DEVIATION REQUEST AND DECISION FORM

Project Name: The Gardens at North Carefree

THE GARDENS AT NORTH CAREFREE
PLAN AND PROFILE
AKERS SIDEWALK 2

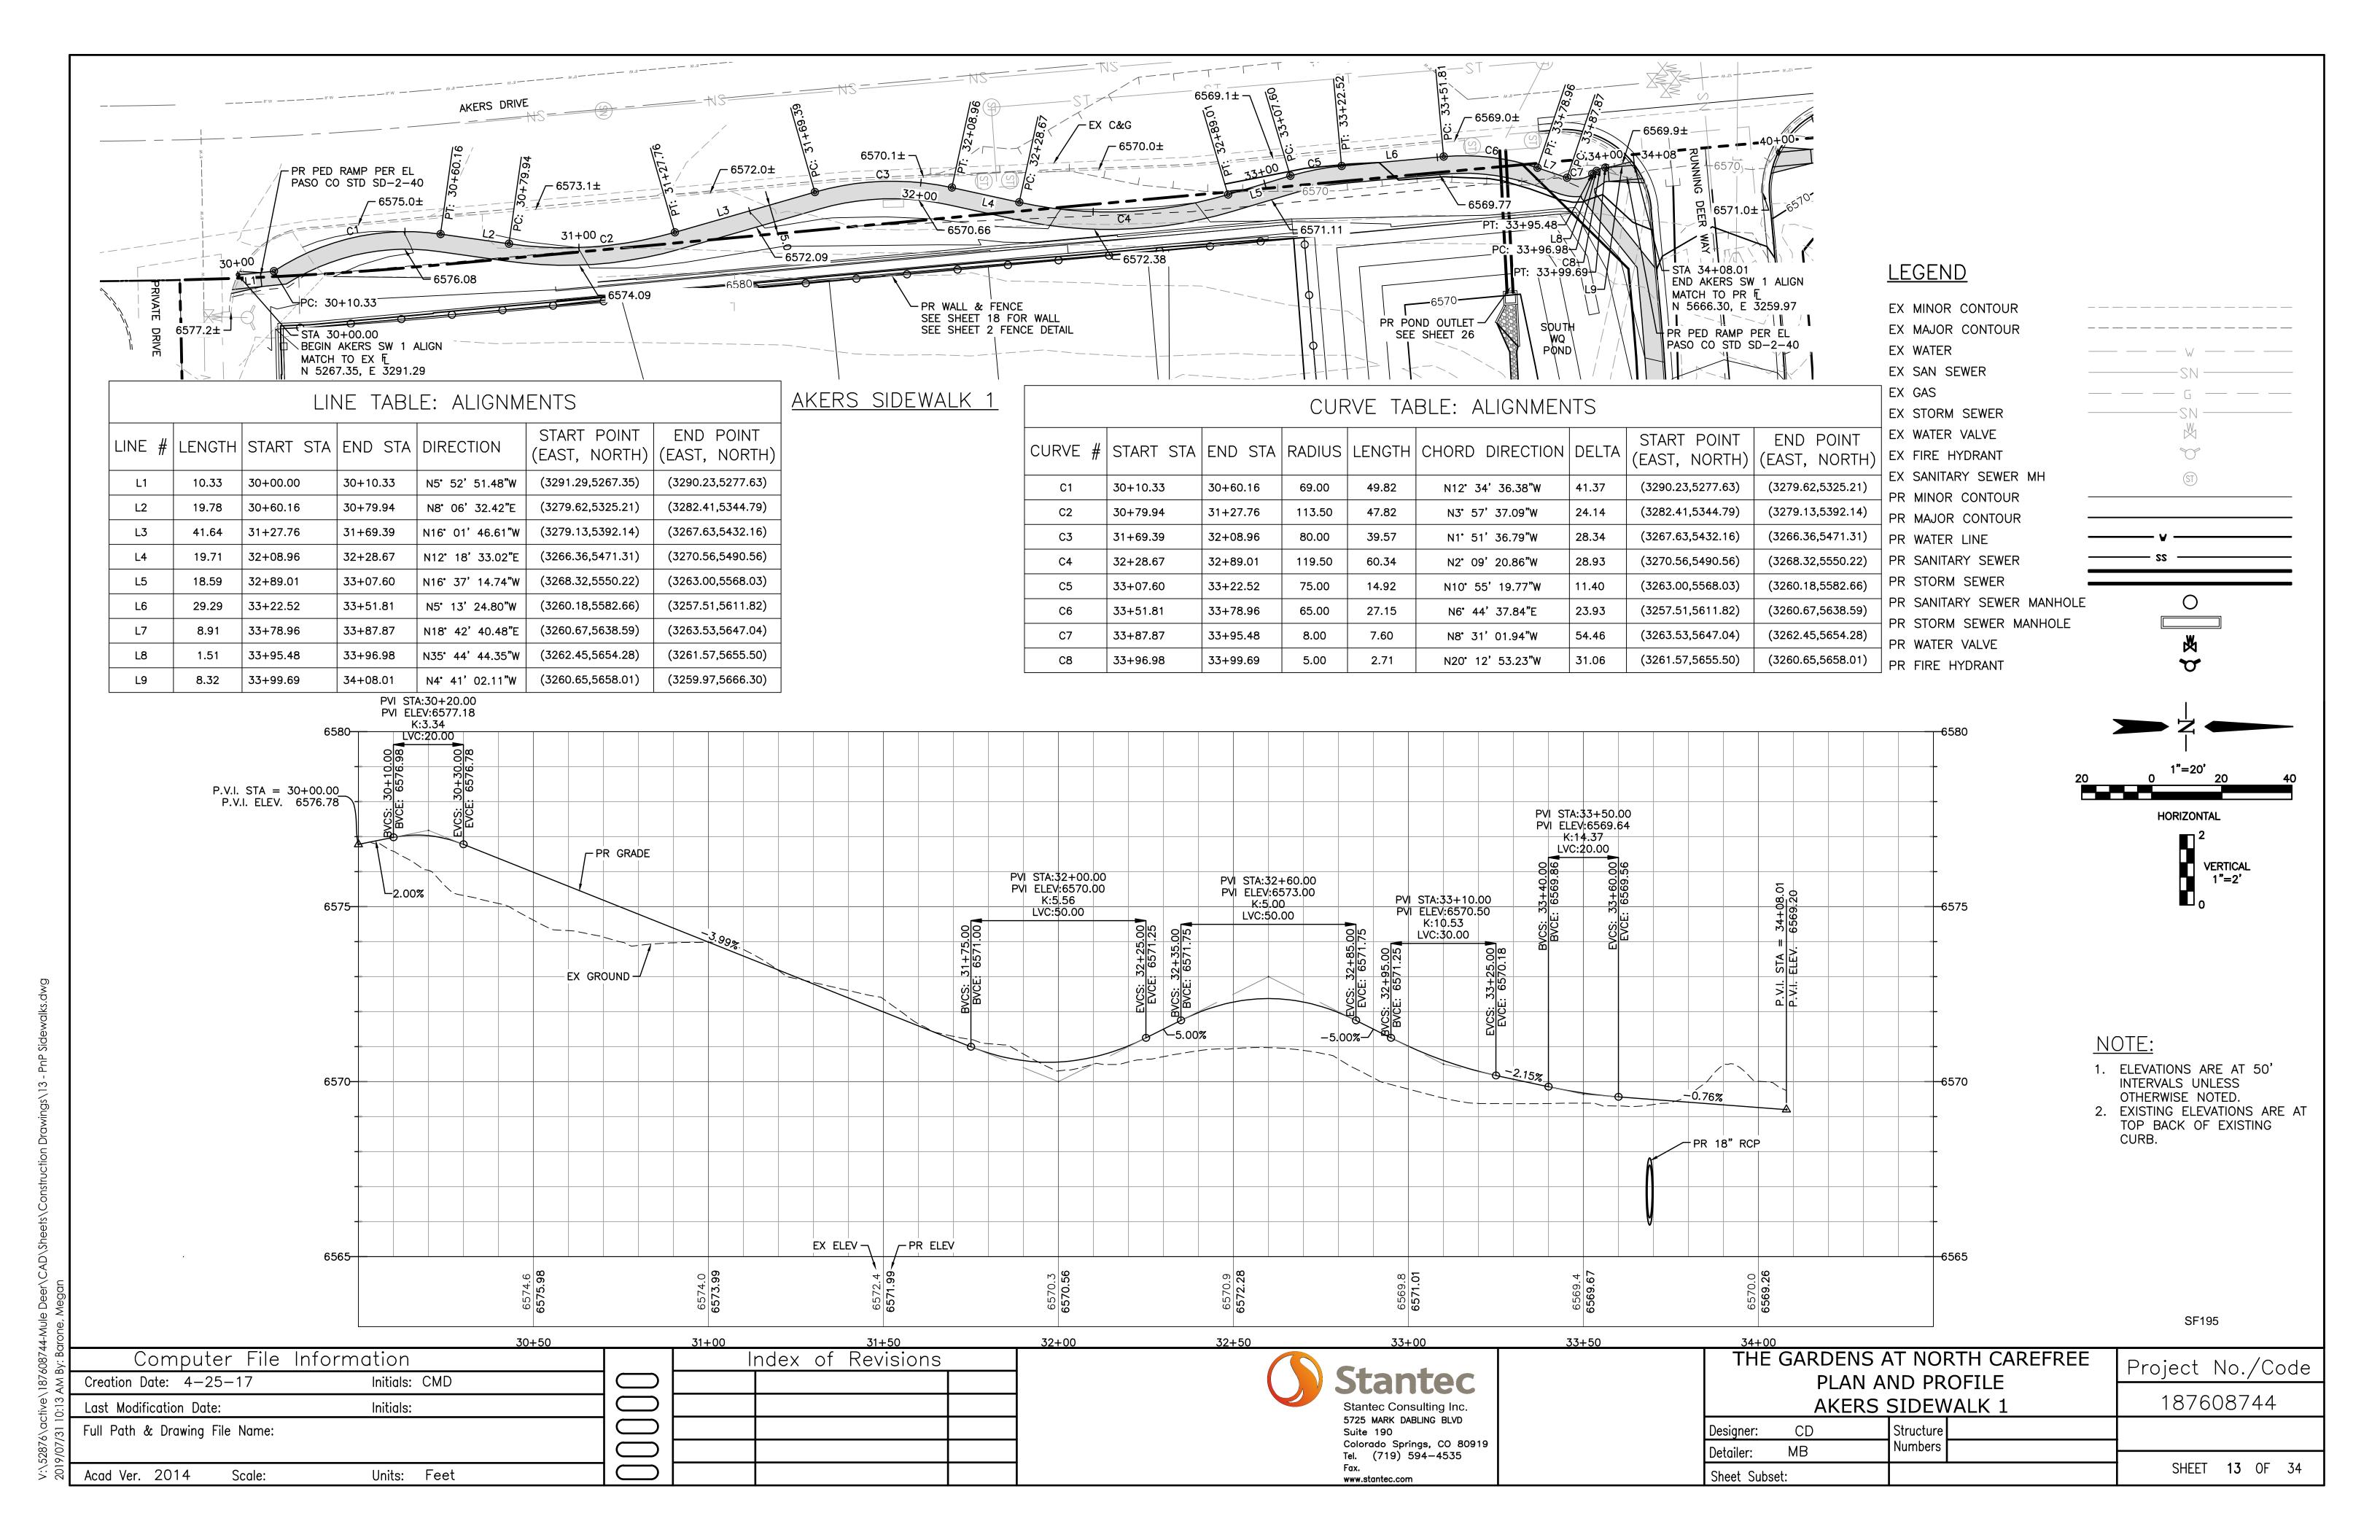
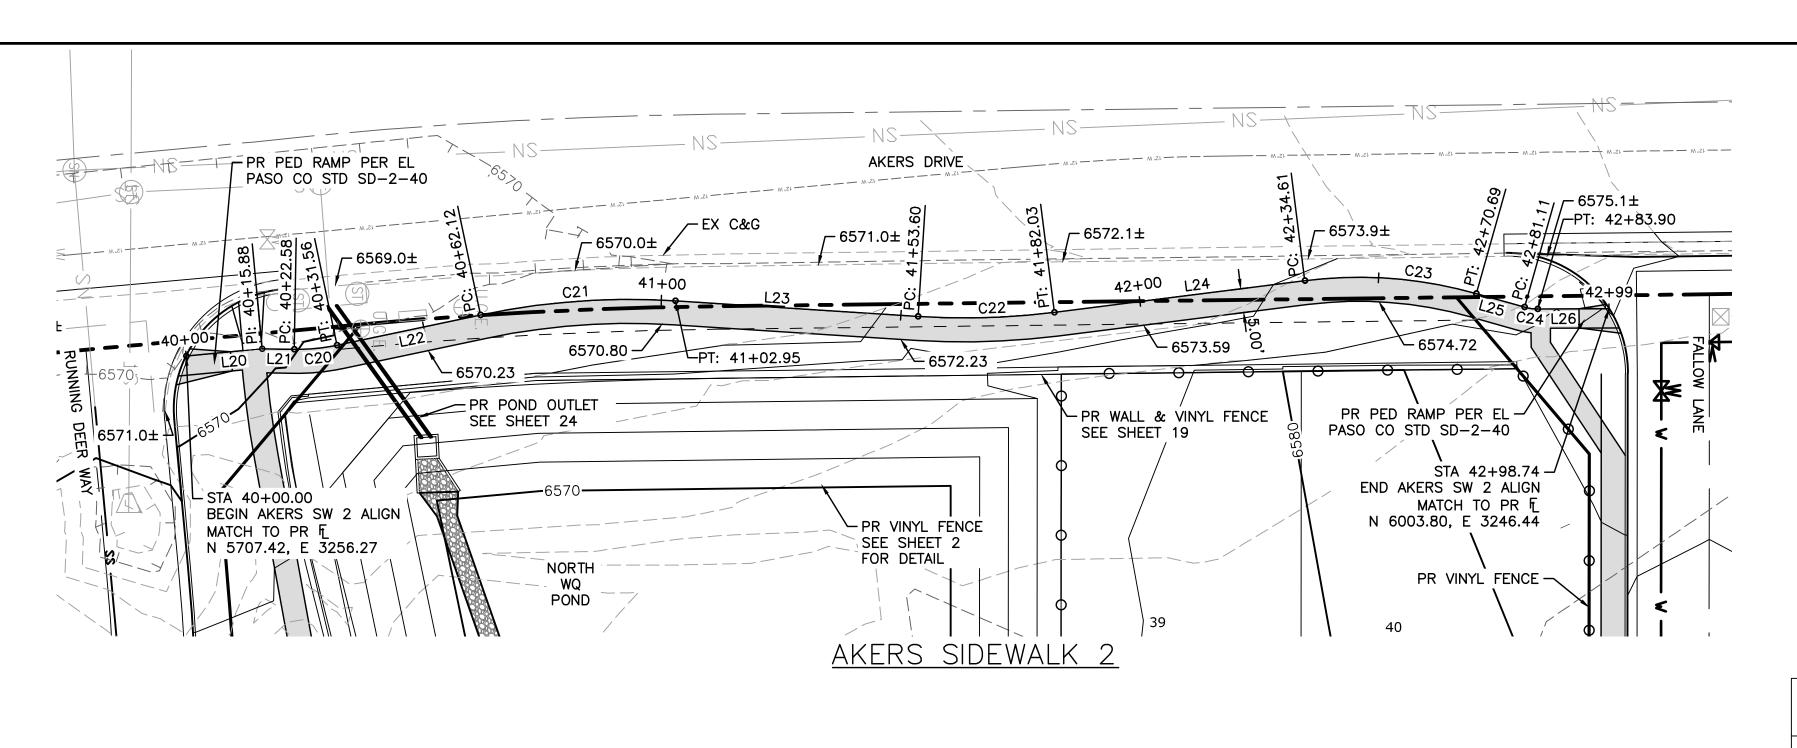
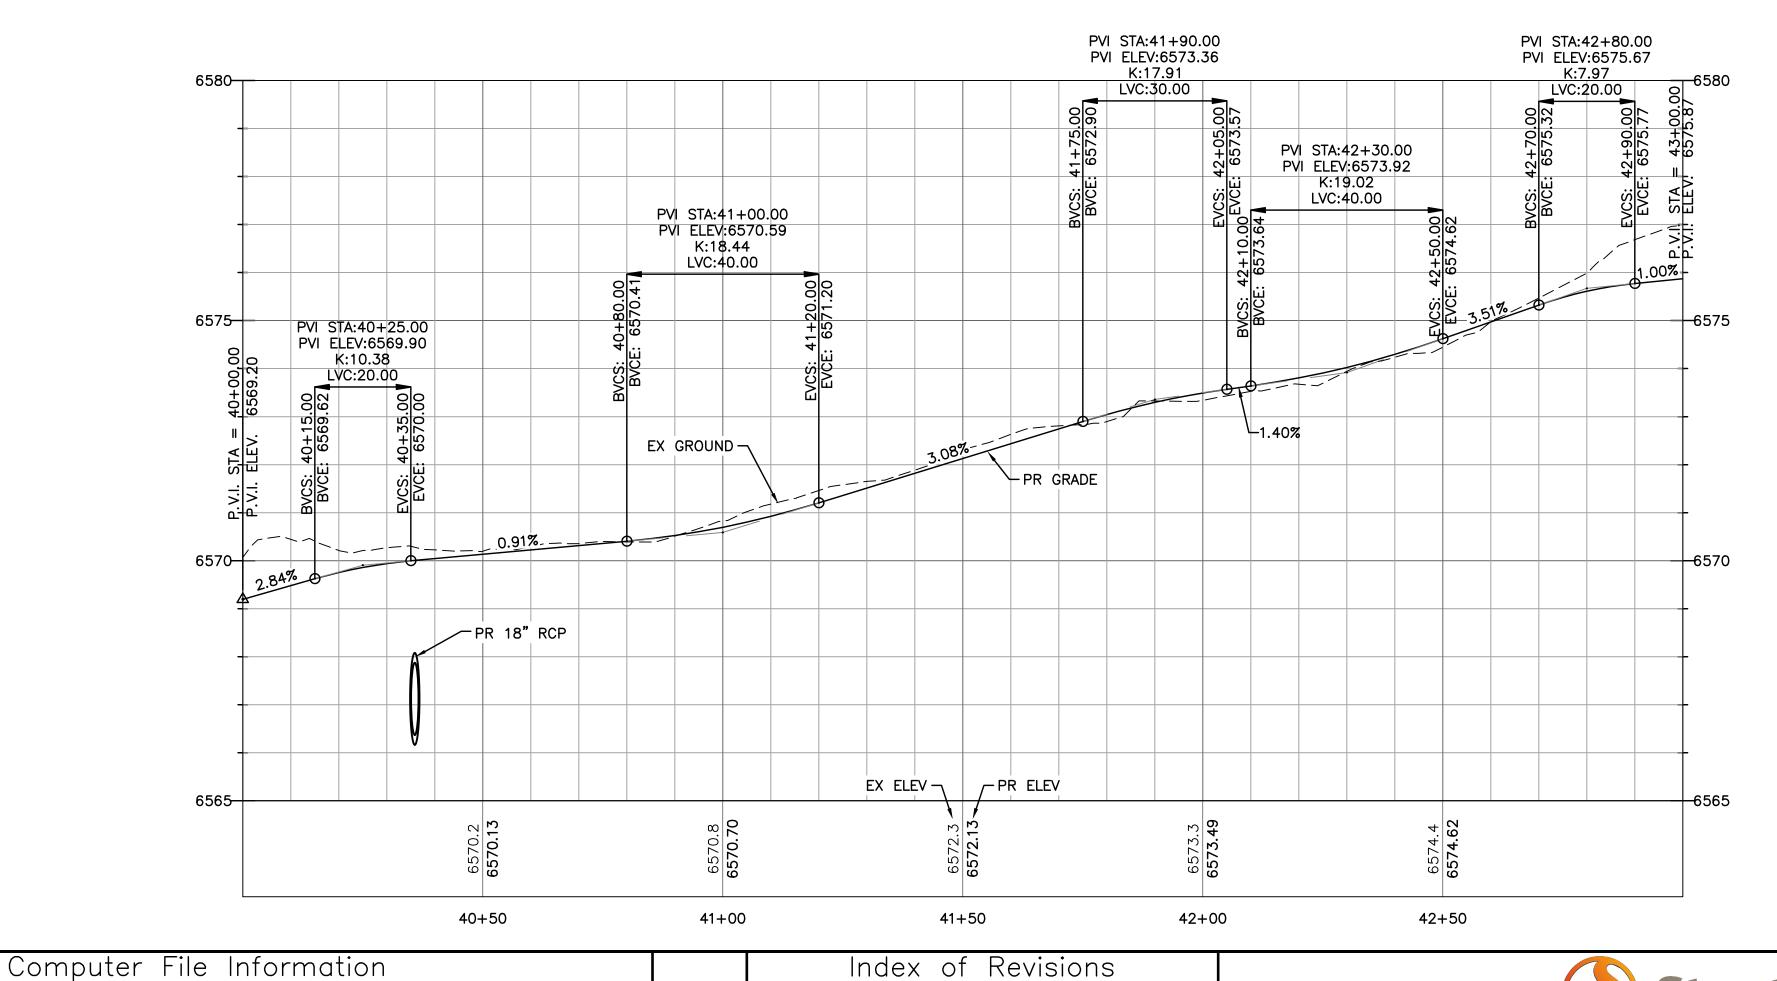
The deviation will achieve the intended result with a comparable or superior design and quality of improvement.  The intended result of a safe pedestrian walkway will be achieved by providing the appropriate walking surface; concrete at 5-ft. wide, and in addition provide a safer "safe harbor" by providing a wider pedestrian area behind the curb with a defacto wider r.o.w. to be used by pedestrians with the plat provision for additional easement to use for the meandering sidewalk. The additional safe area is only provided in the stretches of sidewalk that meander away from the curb; where the sidewalk is located at the standard distance behind the curb the additional safe area does not apply.
The deviation will not adversely affect refety or operations
The deviation will not adversely affect safety or operations.  The function of the sidewalk will be the same or better with the additional safe area behind the curb. The additional safe area is only provided in the stretches of sidewalk that meander away from the curb; where the sidewalk is located at the standard distance behind the curb the additional safe area does not apply.

The deviation will not adversely affect maintenance and its associated cost.
he sidewalk width will be the same. Sidewalk maintenance cost will be the same.
he deviation will not adversely affect aesthetic appearance.
he deviation will improve the aesthetics along the roadway by providing a meandering sidewalk.
The deviation meets the design intent and purpose of the ECM standards.
The deviation meets the design intent and purpose of the ECM standards.  The deviation meets the design intent by providing a 5-ft. wide sidewalk for pedestrians to travel behind the curb.
The deviation meets the design intent and purpose of the ECM standards.  The deviation meets the design intent by providing a 5-ft. wide sidewalk for pedestrians to travel behind the curb.
The deviation meets the design intent and purpose of the ECM standards.  The deviation meets the design intent by providing a 5-ft. wide sidewalk for pedestrians to travel behind the curb.

Approved by the ECM Administrator			
This request has been determined to have met the criteria for approval hereby granted based on the justification provided.	A deviation from Section _	ECM 2.2.4 B	of the ECM is
Approved By: Elizabeth Nijkamp Date:01/16/2020	٦		
El Paso County Planning & Community Development	J		
Denied by the ECM Administrator			
This request has been determined not to have met criteria for approval hereby denied.	A deviation from Section _		_ of the ECM is
Γ	٦		
L	Г		
ECM ADMINISTRATOR COMMENTS/CONDITIONS:
